ATTACHMENT TO SE
TROJAN NUCLEAR PLANT

SAIC-85/1034

TECHNICAL EVALUATION
OF THE
DETAILED CONTROL ROOM DESIGN REVIEW
OF THE
TROJAN NUCLEAR PLANT

May 2, 1985

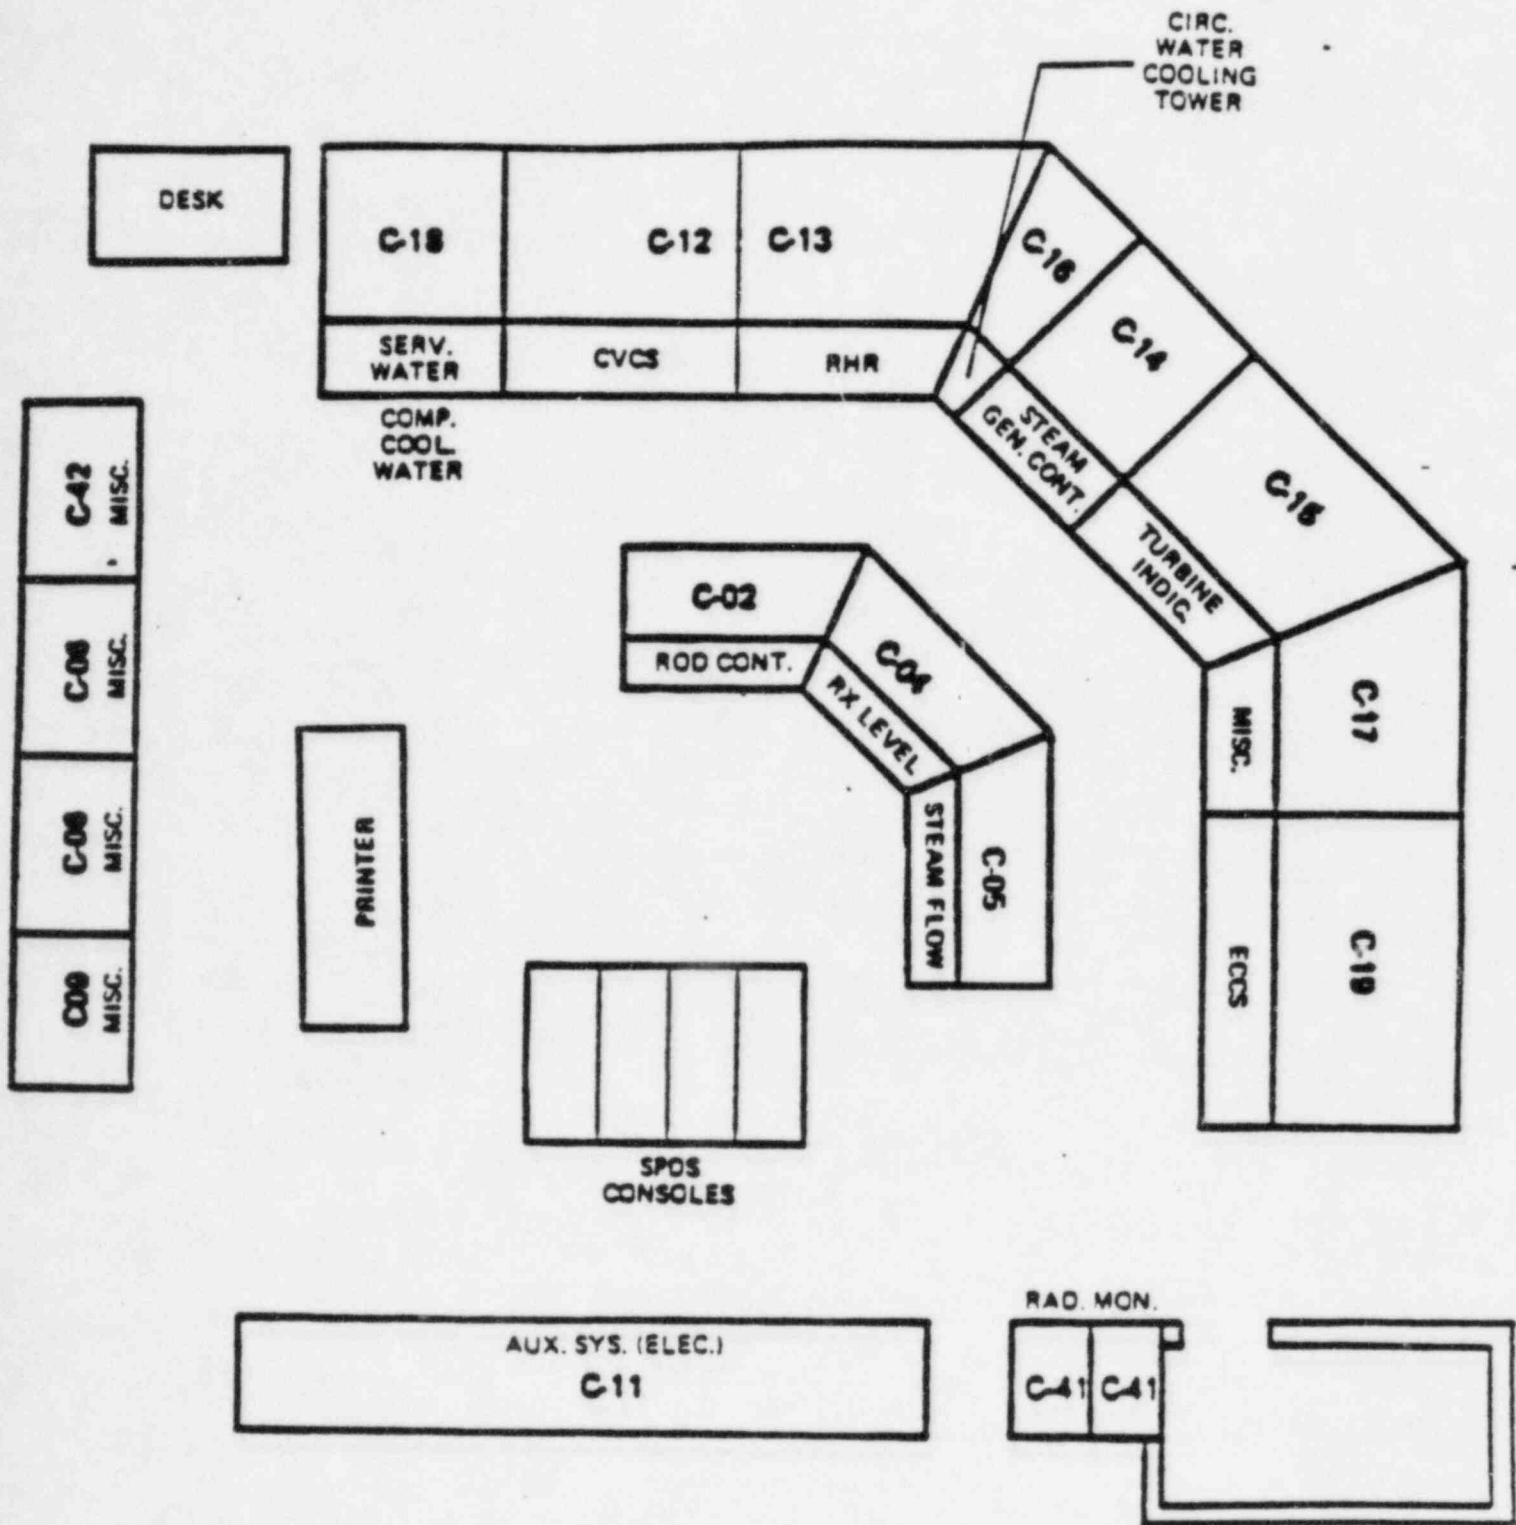
In the pre-implementation audit team's judgment, the verification process should pay particular attention to color usage. PGE currently plans to use color padding along with color in mimics, labels, and demarcation. Although the number of colors to be used in color padding is within the NUREG-0700 color usage guidelines for an enhancement ($n=11$), the number, types, and variations of colors used in color padding when integrated with the number, types, and variations of colors used in mimics, labels, and demarcation violates the guidelines for color usage. In the pre-implementation audit team's judgment, this concern should be addressed thoroughly during the verification process. If safety-significant problems are identified during verification, PGE should reevaluate the use of color padding.

According to our understanding of color usage in the modified main control room design as illustrated by photographs of the Trojan control room and the depiction of color padding on control panel drawings, the following table is an approximate description, by panel, of colors to be used. A diagram of the control layout is included in this appendix.
